LOCAL PLANNING PANEL MEETING

Item 1	LPP21/25 DA/784/2025 - Demolition and Construction of a Childcare Centre - 61 Cardinal Avenue, Beecroft	1
--------	--	---

DA No:	DA/784/2025 (PAN-551600 - Lodged on 21 July 2025)
Description:	Demolition of existing structures and construction of a 60 place childcare centre with basement car parking
Property:	Lot 31 DP 1208231, No. 61 Cardinal Avenue, Beecroft
Applicant:	Audaa Pty Ltd
Owner:	Mr Mourad Gergis and Mrs Fefi Gergis
Estimated Value:	\$1,725,485.14
Ward:	C Ward
Clause 4.6 Request:	Nil
Submissions:	87 submissions in objection and 1 petition containing 86 signatures
LPP Criteria:	10 or more unique submissions were received by way of objection
Author:	Katrina Maxwell, Senior Town Planner
COI Declaration:	No Council staff involved in the assessment of this application have declared a Conflict of Interest.

Figure 3: Long Section of Site Showing Deep Soil Under Play Area (Source Audaa Pty Ltd)

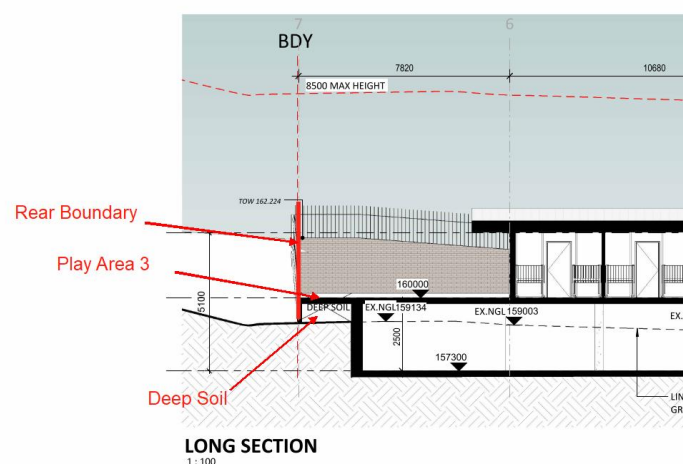
The architectural and landscaping plans show deep soil planting under raised ground slabs. The area shown in light green in Figure 3 below would be over the proposed basement and would consist of decking to the rear and the light green area to the northern side would sit above the basement and be covered in artificial turf.

While deep soil planting is shown on the architectural/landscaping plans. The majority of rear outdoor play area is elevated and cantilevered over the deep soil area, resulting in no opportunity for soft landscaping in this location. The majority of the area on the site that does contain deep soil would be covered with artificial turf.

Figure 4: Southern Elevation showing raised play area

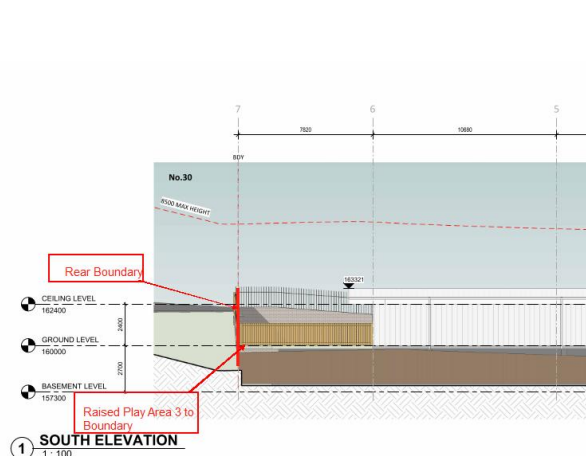
Between the southern elevation of the basement and the southern property boundary the site would be excavated. The southern elevation would be 7m in height from its excavated level. Therefore, any landscape screening within this landscape strip would need to have a mature height of between 5 to 7m to provide meaningful screening of the development from the adjoining properties.

Additionally, the raised playground would be setback 2m from the southern side setback. The play area would be raised 0.9m above existing ground level. An amended landscape plan has not been provided, so based on the architectural plans dated 15 October and the landscape plans dated 10 April 2025, a 1.8m high acoustic barrier would be installed at existing ground level and therefore would only screen up to a height 0.9m of the outdoor play area. It is unclear what landscaping screening of the raised play area would be proposed as this is not specified on the landscape plan.

Figure 5: Site Plan Showing 2m deep soil at rear flush with the rear boundary

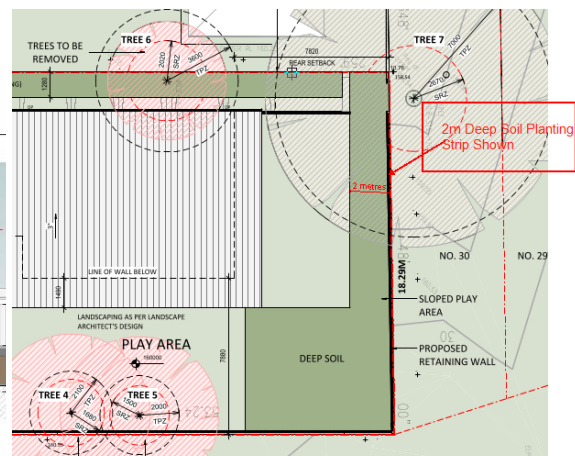
Council requested that a clear delineated 2m deep soil planting strip is required along the entirety of the southern side boundary. The landscape strip was to be capable of supporting plant and tree growth and must not include any buildings, structures, or hard-paved surfaces. The applicant provided amended plans depicting a 1.2m landscaping strip along the southern boundary. An amended landscaping plan was not provided with the amended architectural plans. Accordingly, the species of landscaping proposed along the southern boundary has not been provided. Therefore, its mature height and ability to grow within a 1m wide south facing landscaping strip is unknown.

Figure 6: Extract of Shadow Diagram Showing Overshadowing of 59 and 59A Cardinal Avenue (winter 12pm)

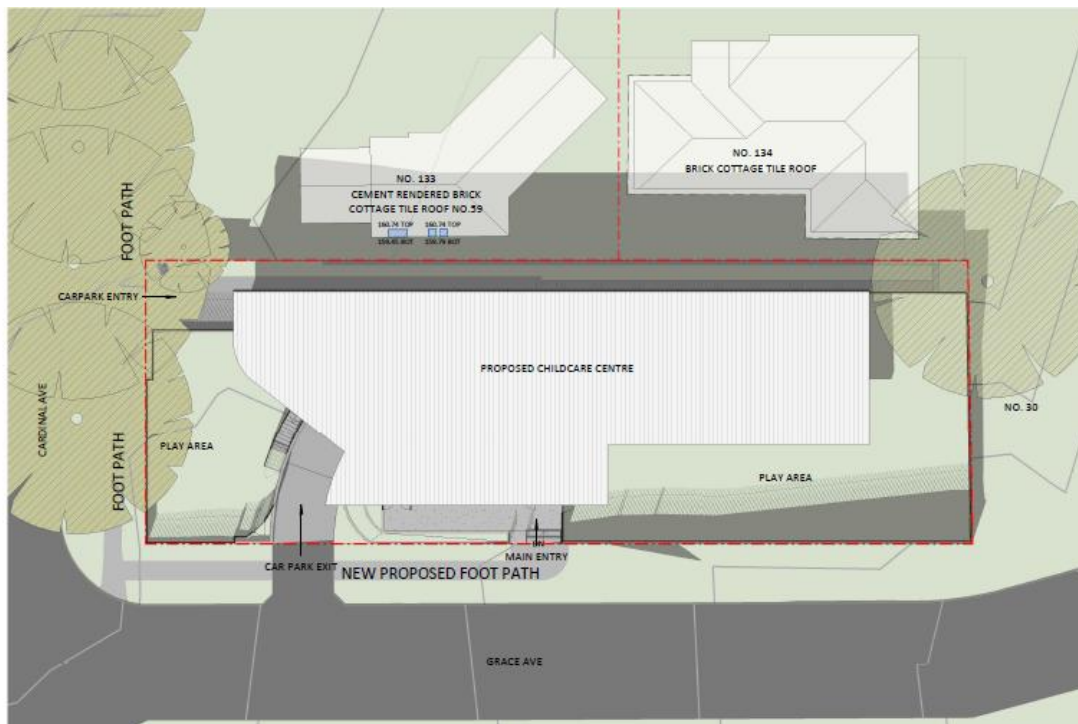
The private open spaces of 59 and 59A Cardinal Avenue would be overshadowed at all times between 9am and 3pm on June 22 and would result in an unacceptable impact to the adjoining properties.

Figure 7: Extract of South Elevation (Source: Audaa Pty Ltd)

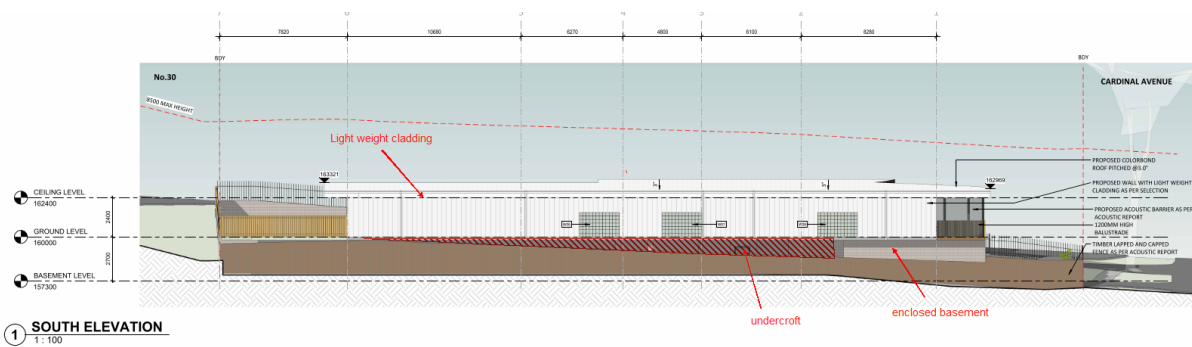
While the development may read as a single storey dwelling at Cardinal Avenue, it would still read as a two storey building 35m long abutted against the southern site boundary of the site. No attempt has been made to provide meaningful visual relief to the adjoining properties to the south such as breaking the building into pavilions, providing an articulated wall length, compliant side setbacks, a variety of building materials and/or finishes, recessed walls flanked by additional landscape screening or other such visual relief.

Monotonous building materials are proposed along the southern boundary, comprising of masonry for the enclosed portion of the basement, and lightweight cladding for the entire first floor of the childcare centre, only broken up with glass brick windows. The southern elevation lists the ground floor elevation as being finished in light weight cladding, however there is no light weight cladding listed in the Materials and Finishes Schedule dated 15 October 2025. It is more likely that the ground floor of the southern elevation would be rendered in "Royal Beige" as per the materials and finishes schedule and consistent with the other elevations of the building.
